# Department of Public Works

## City of Everett ADA Transition Plan

July 2018

# Department of Public Works

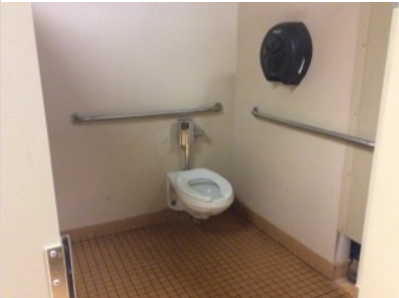
ID	Location	Floor	Room	Element	Type	Photo	Issues	Current Measure	Recommendations	Quantity	Price	Cost Estimation
5	Parking Lot	Ext.		Off-Street Parking Lot or Garage	Visitor		Access aisle not provided Sign < 60" above finished grade	- 55"	Provide a marked access aisle that is at least 60" wide./Provide a marked access aisle that is at least 96" wide. Locate sign with the bottom of the sign 60" above the ground.	1	150 Labor	\$150
Access to Goods and Services												
Doors, Doorways, & Gates												
6	Main Entrance	1		Doors, Doorways, & Gates	Circulation		Automatic door opener not operable	-	Repair or replace the door opener.	2	1530	\$3060
Signage												
7	Staff Break Room (Used for Voting)	1		Signage	Designation		Not provided Raised characters not provided Braille not provided	- - -	Locate signage alongside the door on the latch side. Provide text with raised characters duplicated in braille.	1	116	\$116

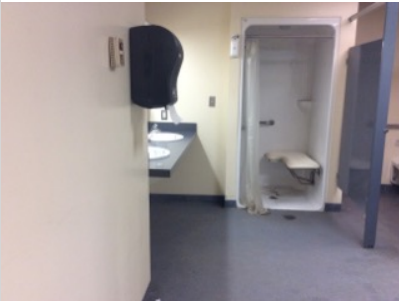
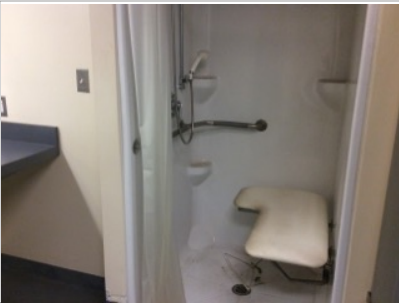
ID	Location	Floor	Room	Element	Type	Photo	Issues	Current Measure	Recommendations	Quantity	Price	Cost Estimation
10	Path to Emergency Exit	1		Signage	Egress		Raised characters not provided Braille not provided	- -	Provide text with raised characters duplicated in braille.	1	116	\$116
Service Counter												
11	Welcome Desk	1		Service Counter	N/A		Counter > 36" high	41"	Provide a counter that is 36" max. above the ground or finish floor.	1	440	\$440
12	Main Entrance	1		Service Counter	N/A		Counter > 36" high	41"	Provide a counter that is 36" max. above the ground or finish floor.	1	440	\$440
Operable Parts												
13	Main Entrance	1		Operable Parts	Equipment		Clear floor space not provided	-	Relocate plants to provide a 30" by 48" clear floor space positioned for a forward approach at call button. Relocate plant.	1	Labor	\$0
Picnic Tables												
14	Main Entrance	Ext.		Picnic Tables	N/A		Number of seating spaces at picnic tables Number of accessible seating spaces Toe or knee clearance at tables not provided	7 0 25"	Provide at least 1 dining surface with toe and knee clearance.	1	700	\$700
